RESOLUTION HOLDING HEARING ON REQUEST FROM BROADLAWNS MEDICAL CENTER TO REZONE PROPERTY LOCATED AT 1801 HICKMAN ROAD FROM "C-0" COMMERCIAL RESIDENTIAL DISTRICT, "R-3" MULTIPLE FAMILY RESIDENTIAL DISTRICT, AND "FW" FLOODWAY DISTRICT TO "PUD" PLANNED UNIT DEVELOPMENT DISTRICT

**BROADLAWNS
CONCEPTUAL
PUD PLAN**

BROADLAWNS MEDICAL CENTER
CLINIC AND RESIDENCY
1801 HICKMAN ROAD
DES MOINES, IOWA

3 OF 3
 CONCEPTUAL
 BUILDING EXTERIOR
 DESIGNS
 PROJECT NO.: 414004
 SHEET NO.: 3 OF 3
 DATE: 06/25/13
 DESIGNED FOR: PUD RESIDENCY
 APPROVED: RCU
 DRAWN: SEL

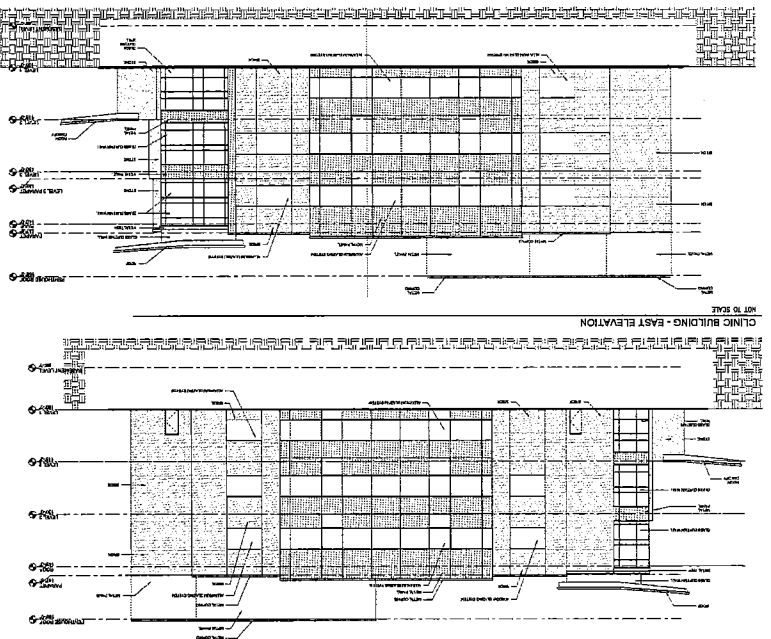
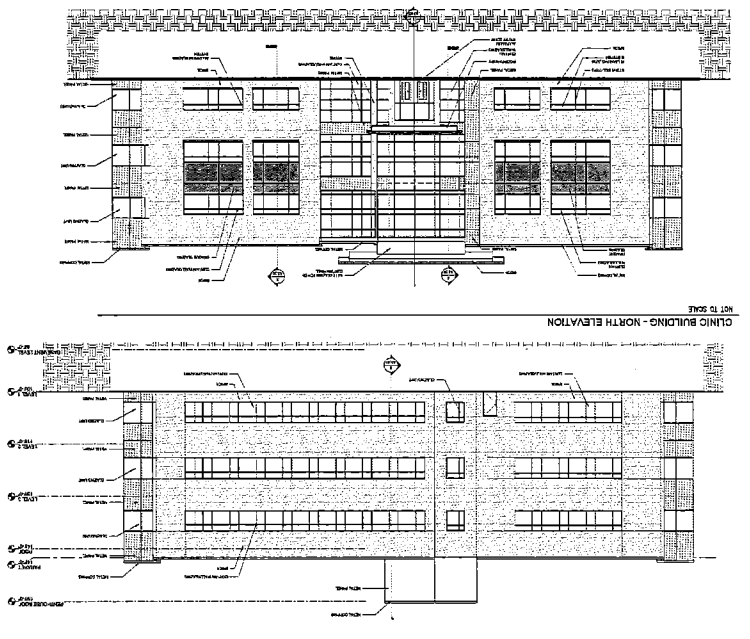
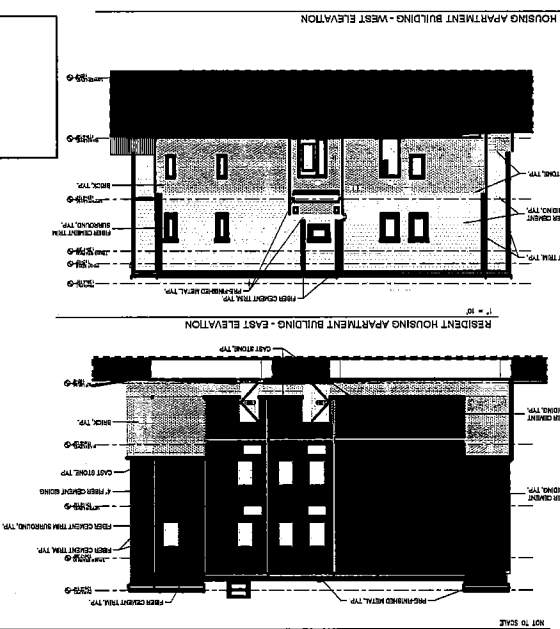
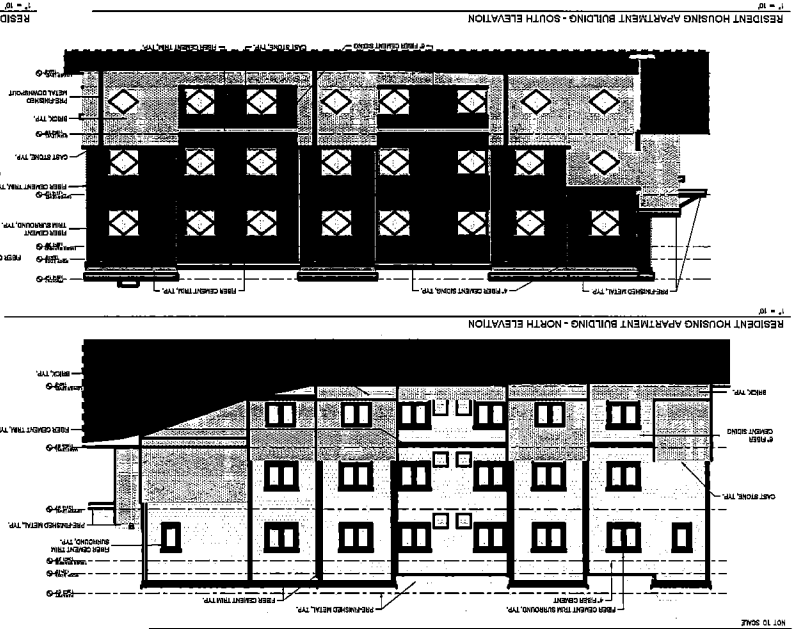
10. The elevations for the multiple-family residential structures shall be revised with a design as approved by the City’s Planning Administrator that provides brick or masonry materials.

11. The elevations for the multiple-family residential structures shall be revised to include additional windows on the west facade to the satisfaction of the City’s Planning Administrator.

7. **Urban Design:** The submitted elevations demonstrate that the medical clinic building would be a 3-story structure, containing 20,000 square feet of area. The structure would be sided primarily with brick, with aluminum glazing accents.

The submitted elevations demonstrate that the two (2) multiple-family residential structures would be 3 stories in height, but due to a change in grade on site, the west façade facing the parking lot would only appear to be 2 stories in height. Thus, the main entrance to each building would be on the second floor. The elevations indicate the buildings would be sided entirely with fiber cement siding. Staff recommends that these elevations be revised to have a design as approved by the City's Planning Administrator that provides brick or masonry materials on at least at least the bottom floor of each

exposed exterior façade and has some brick or masonry details on the upper level(s). The elevations of the building indicate the north and south side facades of the structures would include a significant number of windows. However, the end facades include very few windows. Staff recommends that the west façade of these buildings, which would face the parking lot and serve at the main entrance, should include additional windows to the satisfaction of the City's Planning Administrator.

Greg Wattier commented that the clinic makes the residence look like low rent housing in the back. He believes they are not far off, but believe there is a compromise in regards to the bricks and wainscot.

Bob Bisenins stated not to put brick on the full height of the first floor on the north, east and south sides of each unit.

10. The elevations for the multiple-family residential structures shall be revised with a design as approved by the City's Planning Administrator that provides brick or masonry materials on at least at least the bottom floor of each exposed exterior façade and has brick or masonry details on the upper level(s).

11. The elevations for the multiple-family residential structures shall be revised to include additional windows on the west facade to the satisfaction of the City's Planning Administrator.
